Intel[®] 82371EB (PIIX4E)

Specification Update

December 1999

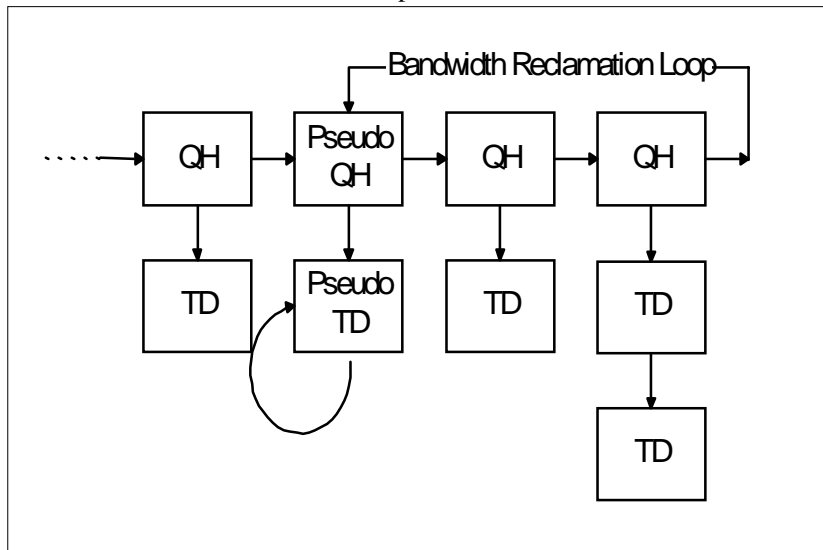
4. USB Bandwidth Reclamation Errata

Problem: This errata affects data transfers in conjunction with a UHCI driver utilizing bandwidth reclamation. In a data structure which implements bandwidth reclamation, when all the queue heads have their terminate bit set (empty QH's), the USB subsystem will be unable to read a new frame pointer and will continuously loop through the bandwidth reclamation queue heads. The effect of the errata is that the USB subsystem will continue to send out Start Of Frame packets but transfer no data. On the PCI bus the PIIX4 will continuously read the queue heads within the bandwidth reclamation loop. For additional information on PIIX4 host controller operation refer to the Universal Host Controller Interface (UHCI) Design Guide (order number 297650).

Workaround: When using bandwidth reclamation, the UHCI driver should insert a pseudo queue head with a pseudo transfer descriptor within the bandwidth reclamation loop. The PIIX4 will fetch this queue head and transfer descriptor on every frame, but will not transfer any data and will never be terminated. The following bits must be properly set to implement the workaround:

TD LINK POINTER (DWORD 0: 00-03h)

The Link Pointer (LP=bits [31:4]) must be set to point to itself.

The Depth/Breadth Select bit (Vf=bit 2) must be set to 0 indicating that the PIIX4 should execute breadth first.

The QH/TD Select (Q=bit 1) must be set to 0 indicating it is a TD.

The Terminate bit (T=bit 0) must be set to 0 indicating that the link pointer field is valid.

TD CONTROL AND STATUS (DWORD 1: 04-07h)

The Active status bit (bit 23) must be left unset at 0 indicating that the PIIX4 should not execute this TD.

QUEUE HEAD LINK POINTER (DWORD 0: 00-03h)

The Queue Head Link Pointer (QHLP=bits [31:4]) must be set to point to the pseudo TD.

The QH/TD Select (Q=bit 1) must be set to 1 indicating it is a QH.

The Terminate bit (T=bit 0) must be set to 0 indicating that the link pointer field points to a valid TD.
